<b>PCN (Product Change Notice)</b>																																
<input type="checkbox"/> Major Change <input checked="" type="checkbox"/> Minor Change																																
<b>PCN Number:</b> PCN_WCAP-FTX2_20250908  <b>Affected Series:</b> WCAP-FTX2  <b>Affected Part Number:</b> see table "PART NUMBER, REVISION & DATASHEET"  <b>PCN Date:</b> 2025-06-06 (YYYY-MM-DD) <b>Effective Date:</b> 2025-09-08 (YYYY-MM-DD)	<b>Change Category:</b> <input type="checkbox"/> Equipment/Location <input checked="" type="checkbox"/> General Data <input type="checkbox"/> Material <input type="checkbox"/> Process <input type="checkbox"/> Product Design <input type="checkbox"/> Shipping/Packaging <input type="checkbox"/> Supplier <input type="checkbox"/> Software																															
<b>Contact:</b> Product Management  <b>Phone:</b> +49 (0) 7942 - 945 5001  <b>Fax:</b> +49 (0) 7942 - 945 5179  <b>E-Mail:</b> pcn.eisos@we-online.com	<b>Datasheet Change:</b> <input checked="" type="checkbox"/> Yes <input type="checkbox"/> No  <b>Attachment:</b> <input type="checkbox"/> Yes <input checked="" type="checkbox"/> No																															
<b>DESCRIPTION OF CHANGE:</b> <p>As a data

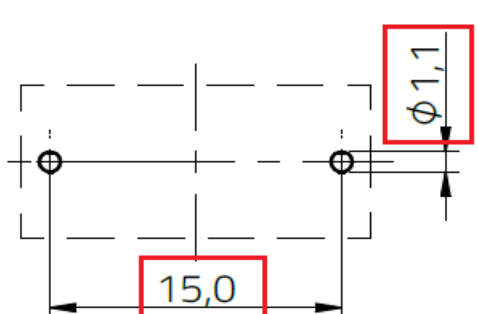
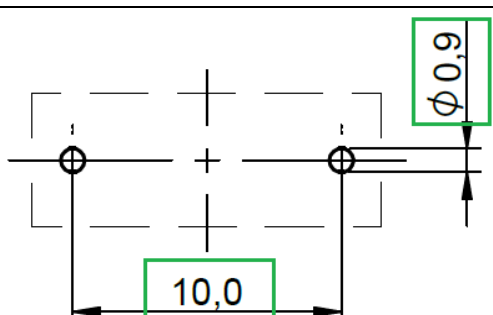
1. "SIZE/TYPE" will be corrected from " Pitch 22.5 mm" into " Pitch 27.5 mm" for below part numbers.

890324027012	890324027025	890324027030
--------------	--------------	--------------

Before Change	After Change
Pitch 22.5 mm	Pitch 27.5 mm

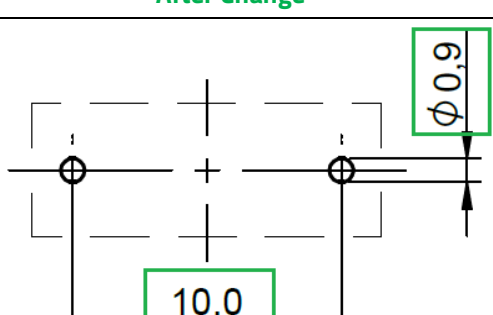
2. "Recommended Hole Pattern Drawing" will be corrected for below part numbers.

890324023007	890324023010	890324023021CS	890324023024CS	890324023025CS
--------------	--------------	----------------	----------------	----------------

Before Change	After Change
